EAST COUNTY SUBSTATION PROJECT

MINOR PROJECT REFINEMENT REQUEST FORM

Date Submitted:	05-17-13 (Originally Submitted) 06-12-13 (Resubmittal) 06-25-13 (Resubmittal)	Request #:	4	
Date Approval Required:	06-28-13	Landowner:]Vj ku'lphto cvkqp'j cu'dggp" tgf cevgf 'f wg'vq'ku'eqphk' gpvkn' pcwtg_"	
APN:]Vj ku'lphto cvkqp'j cu'dggp'tgf cevgf 'f wg'vq'ku'eqphk' gpvkn'pcwtg_			
Refinement from (check all that apply):				
<input type="checkbox"/> Mitigation Measure	<input type="checkbox"/> APM	<input checked="" type="checkbox"/> Project Description	<input type="checkbox"/> Drawing	<input type="checkbox"/> Other
Identify source (mitigation measure, project description, etc.):				
<p>Page C-26 and Figure C-4B in Section C. Alternatives of the Final Environmental Impact Report/Environmental Impact Statement (EIR/EIS) for the East County (ECO) Substation Project (Project) describe and depict the alignment of the main access road to be constructed from Old Highway 80 southeast to the ECO Substation, which is now referred to as the Southern Access Road. Figure C-4B of the Final EIR/EIS depicts the 138 kilovolt (kV) Overhead Transmission Line between the ECO Substation and Old Highway 80, which

Figure 1: Southern Access Road Refinement – Requested and No Longer Required Areas

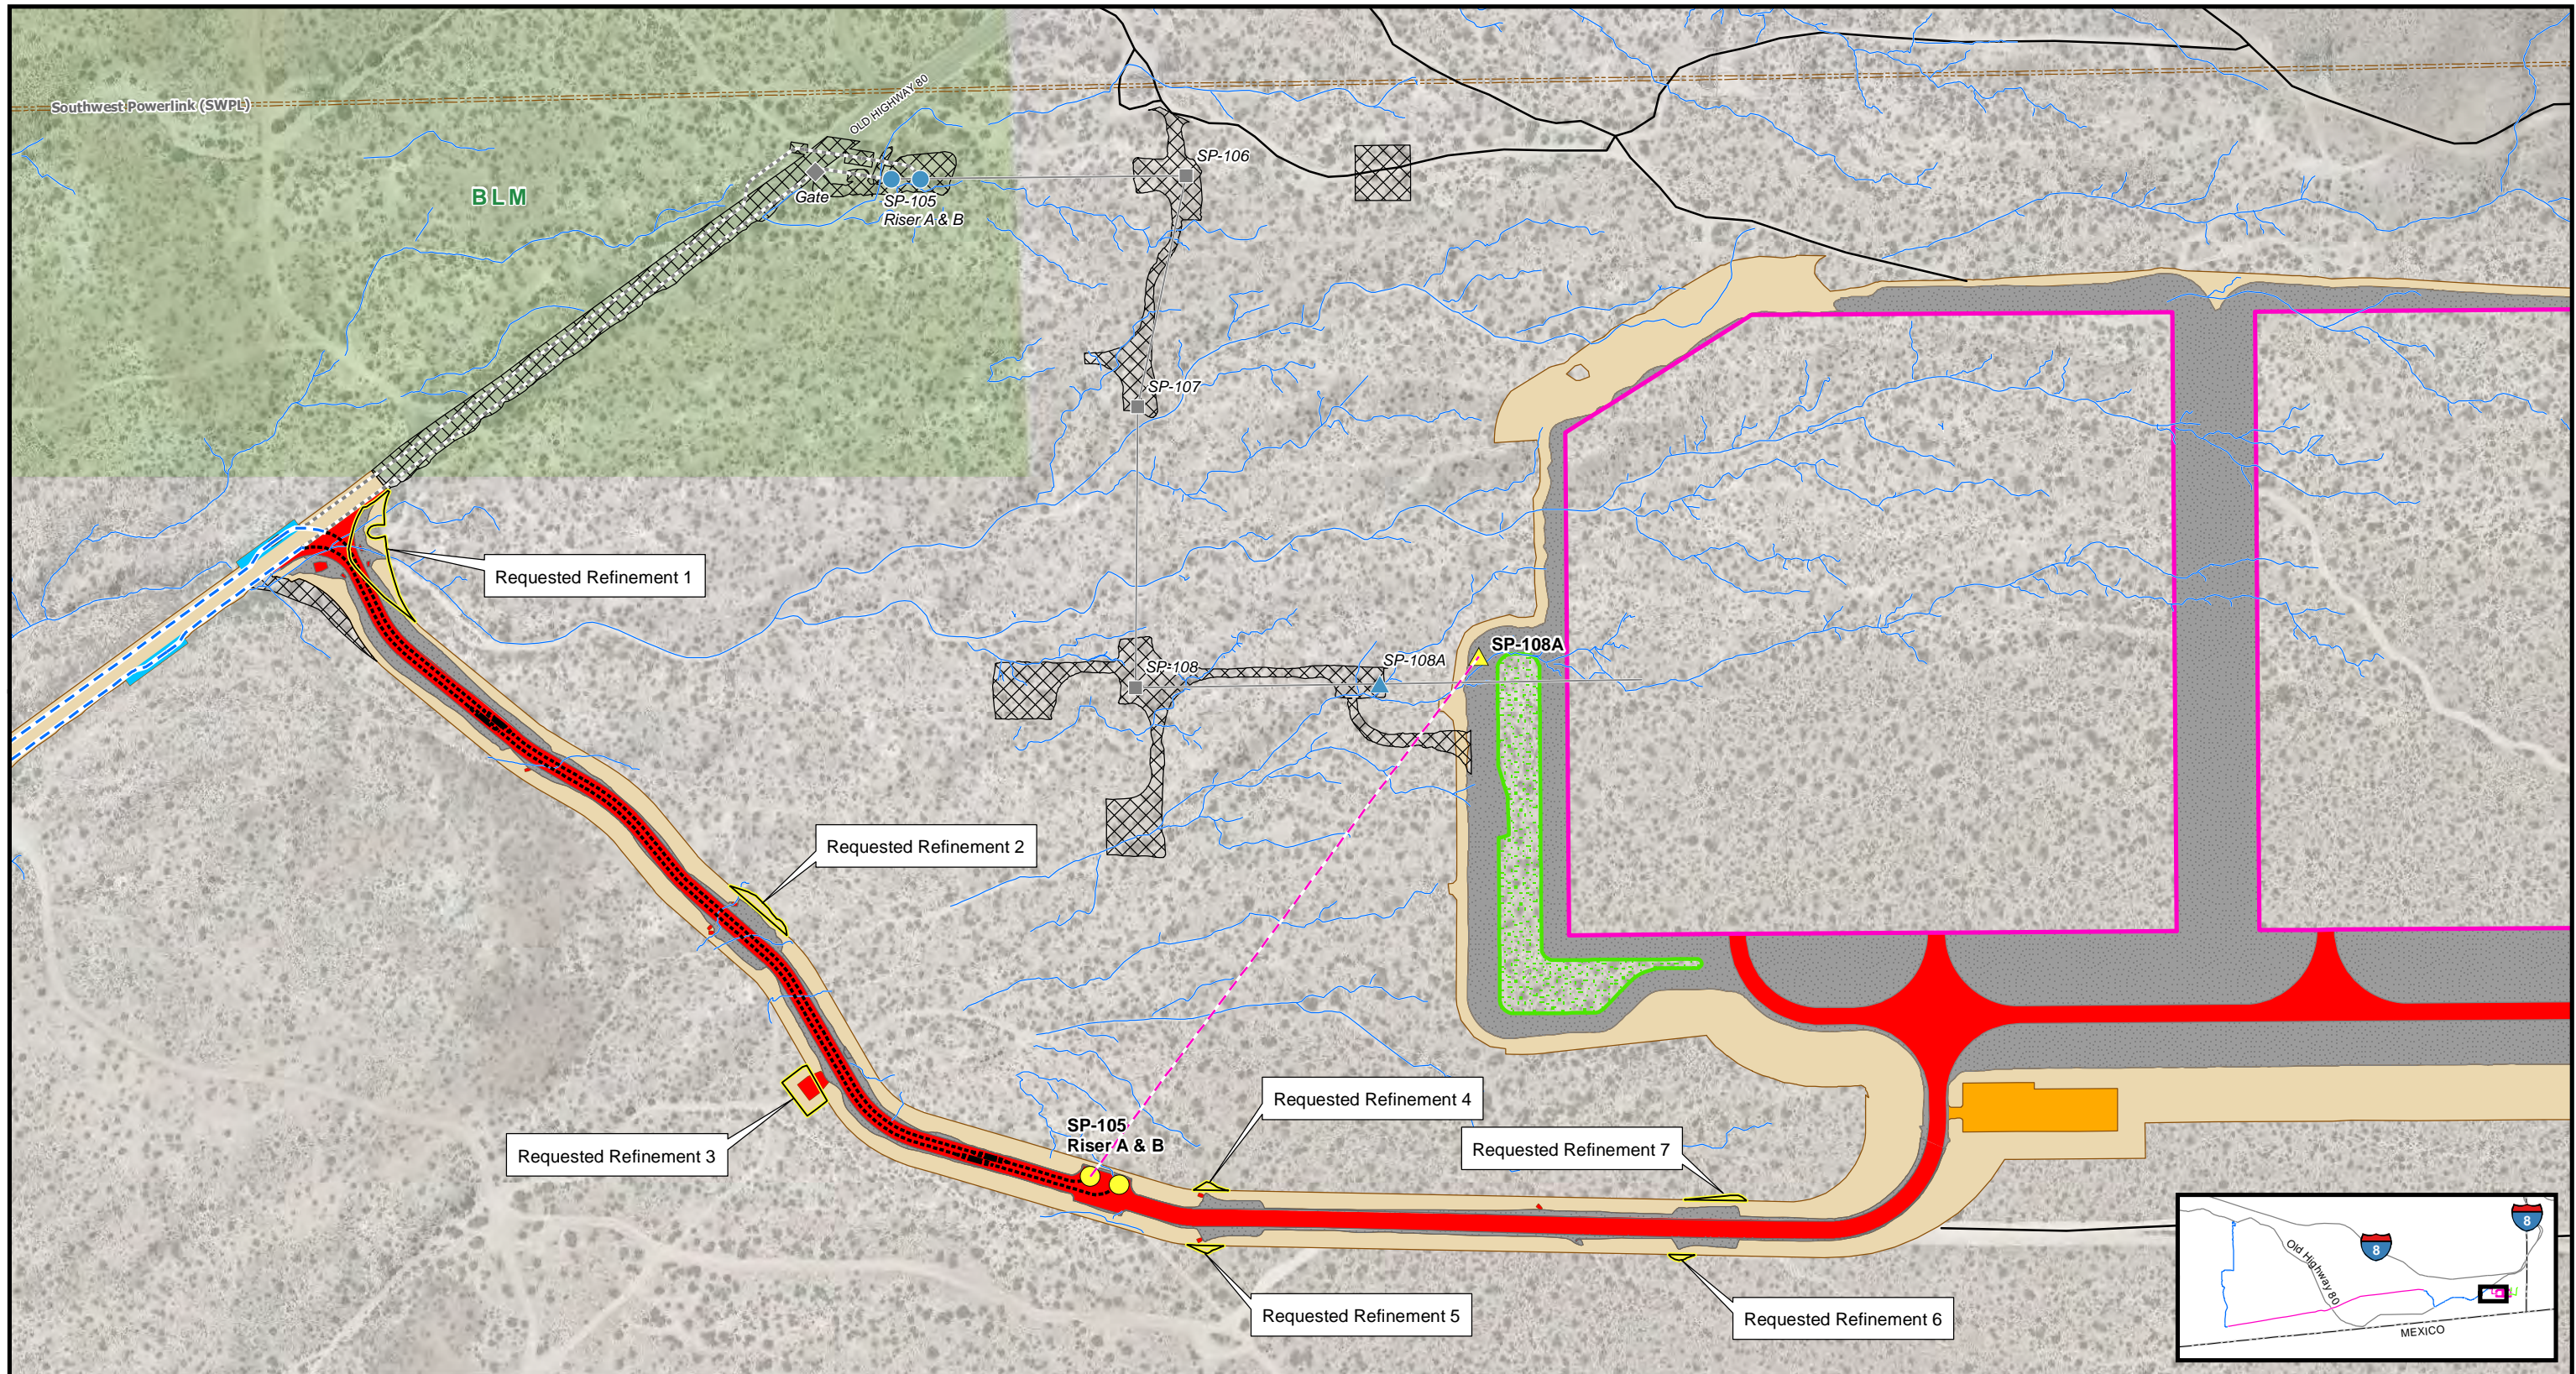
The requested shift of the entrance to the Southern Access Road, as well as minor adjustments to the alignment, include a total of approximately 0.39 acre outside of the approved Southern Access Road alignment, which was established along the centerline of an existing unpaved access road. Figure 1: Southern Access Road Refinement – Requested and No Longer Required Areas in Attachment C: Site Maps depicts the locations of the approved and requested Southern Access Road alignment.

Seven new impact areas are identified on Figure 1: Southern Access Road Refinement – Requested and No Longer Required Areas in Attachment C: Site Maps. An overview of the need, activities, and temporary and permanent impact calculations associated with each of these refinement areas is provided in Attachment D:
